APPLICATION FOR CERTIFICATE OF APPROPRIATENESS HISTORIC CONSERVATION BOARD PUBLIC HEARING STAFF REPORT

Nature of Request:

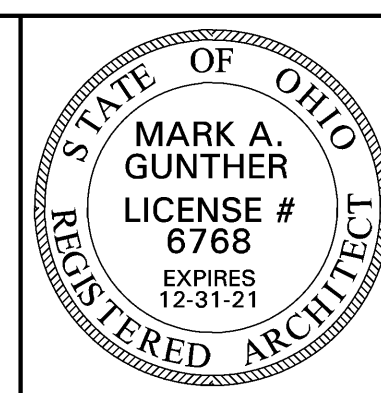
1. ARCHITECT AS USED IN THESE DOCUMENTS REFERS TO WICHMAN GUNTHER ARCHITECTS, INC. 810 PLUM STREET CINCINNATI, OHIO 45202
2. GENERAL CONTRACTOR IS RESPONSIBLE FOR CHECKING ALL CONTRACT DOCUMENTS, FIELD CONDITIONS AND DIMENSIONS FOR ACCURACY. IF THERE ARE ANY QUESTIONS REGARDING THESE OR OTHER COORDINATION QUESTIONS, THE CONTRACTOR IS RESPONSIBLE FOR OBTAINING A CLARIFICATION FROM THE ARCHITECT BEFORE PROCEEDING WITH WORK. A QUESTION OR RELATED WORK.

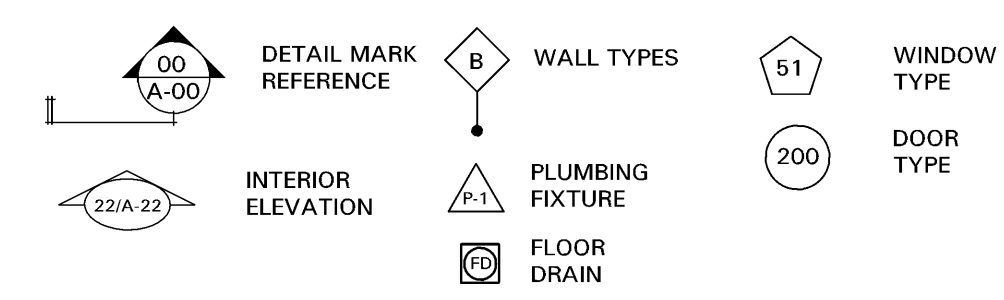
Plot data name: A0268EMcMicken.dwg Date: December 10, 2019 Issue: plan review
